**Subject:** bEMCAL Installation meeting Questions

We had a short meeting today amongst ourselves to talk about the BIC support and install. We came up with a list of questions / concerns that we would like to discuss tomorrow and we wanted to share them ahead of time.

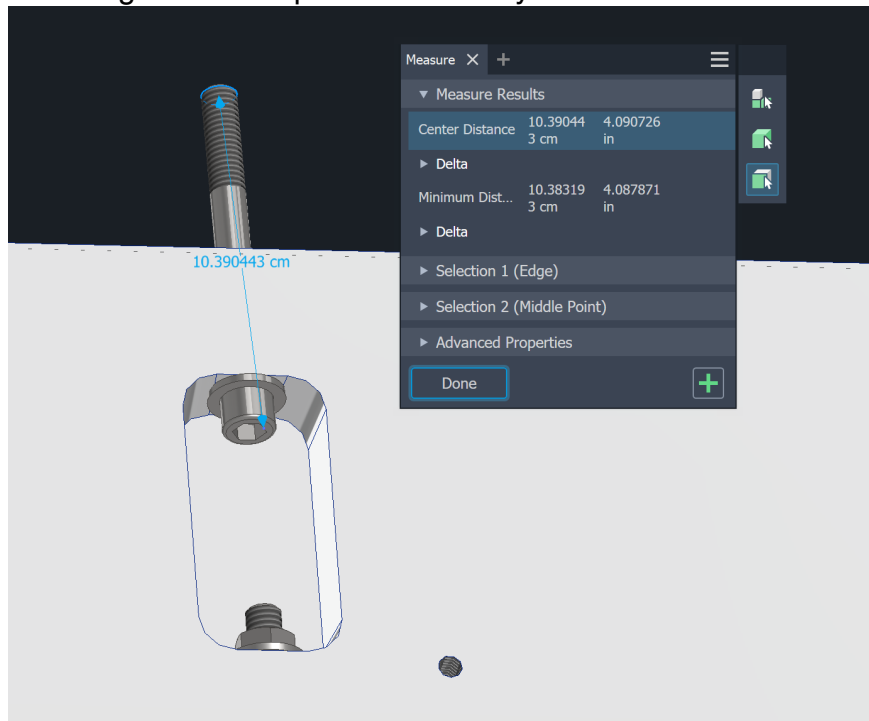
- We would like to add more of the 1/2" tapped holes along the length of the detector in a similar pattern to what already exists. They will be used to attach the support structure to the emcal. IS there any issues or concerns with this? Also can they be made 5/8"?
- Can the pockets be made deeper such that the washers don't stick proud of the face?

- While looking at the model today we noticed that the bolts that connect the sectors were longer than the pockets that they have to fit into.
